Sumter City-County Planning Commission

September 24, 2025

SD-25-02, 4565 Patriot Parkway - Patriot Gardens (County)

Request: A request for preliminary subdivision approval to develop a 12-lot

Figure 1 - Site Plan Layout

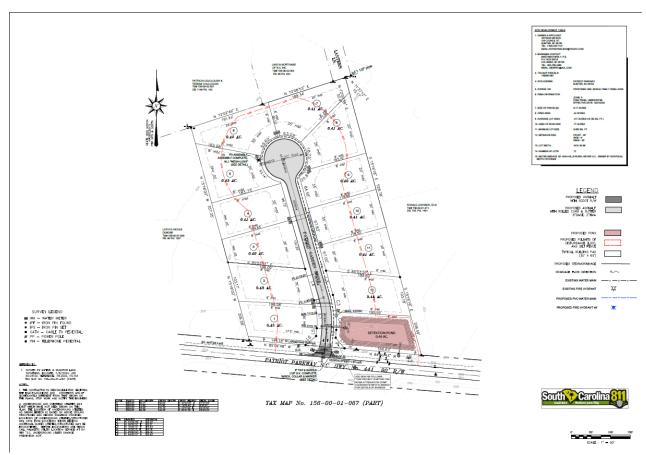
The proposed preliminary plan shows proposed single family detached lots ranging in size from 0.39-acres to 0.44-acres. The lot width for each lot as shown on the plan varies, but all are over 60ft.

The proposed Patriot Garden Drive is considered "medium intensity" per the street standards outlined *Article 8* of the Ordinance. The street will not have on-street parking, will have a 24 ft. pavement width, and 50 ft. total right-of-way (ROW) area. No sidewalks are required or proposed. The street plans meet the minimum requirements of the Ordinance. A full engineering review of the street plans will be conducted by the Sumter County Public Works Department prior to approval to proceed with construction.

The stormwater management plan for this subdivision shows one proposed stormwater retention facility located at the front of the property along Patriot Parkway. Stormwater from the development will be collected via inlet and piped to the detention pond located at the front of the development.

1. The subdivision shall be developed in substantial conformance with the revised preliminary plat titled, "*Patriot Gardens Sumter, South Carolina*" (*Sheet C3*), prepared by Michael E. Weatherly, P.E., Consulting Engineer and dated September 12, 2025.

Figure 2- Landscape Plan

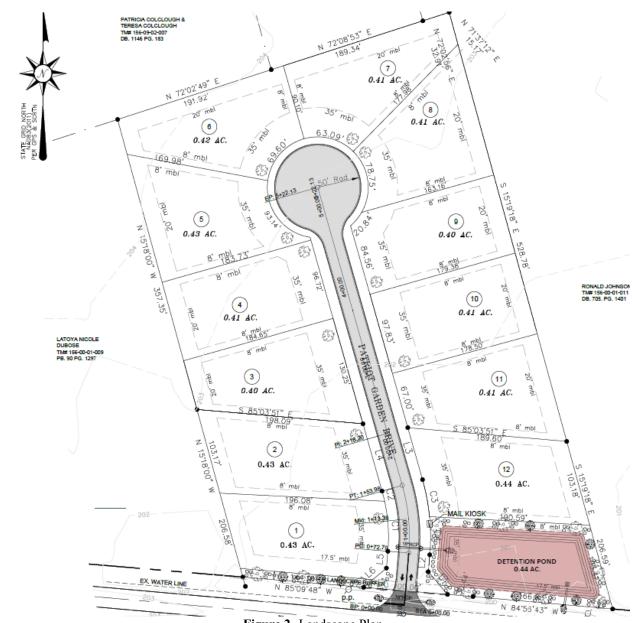
Proposed landscaping details have been included in the submitted plans. The applicant is proposing to plant a total of 25 Canopy Trees (*Oak*), 9 Evergreen Trees (*Sweet Bay Magnolia*), and 80 shrubs (*Burford Holly, Ruby Loropetalum, and Oakland Holly*). A portion of these plantings will be placed along the property's Patriot Parkway frontage, and a portion will be used to screen the stormwater facility. There will also be 1 canopy tree planted per lot.

- a. Stormwater Pond Buffer All required stormwater pond buffering must be complete and pass zoning inspection prior to final plat approval for any lot in the subdivision.

- b. Street Trees/Front Yard Planting of at least 1 canopy tree in the front yard of each lot is required prior to certificate of occupancy approval for that lot.
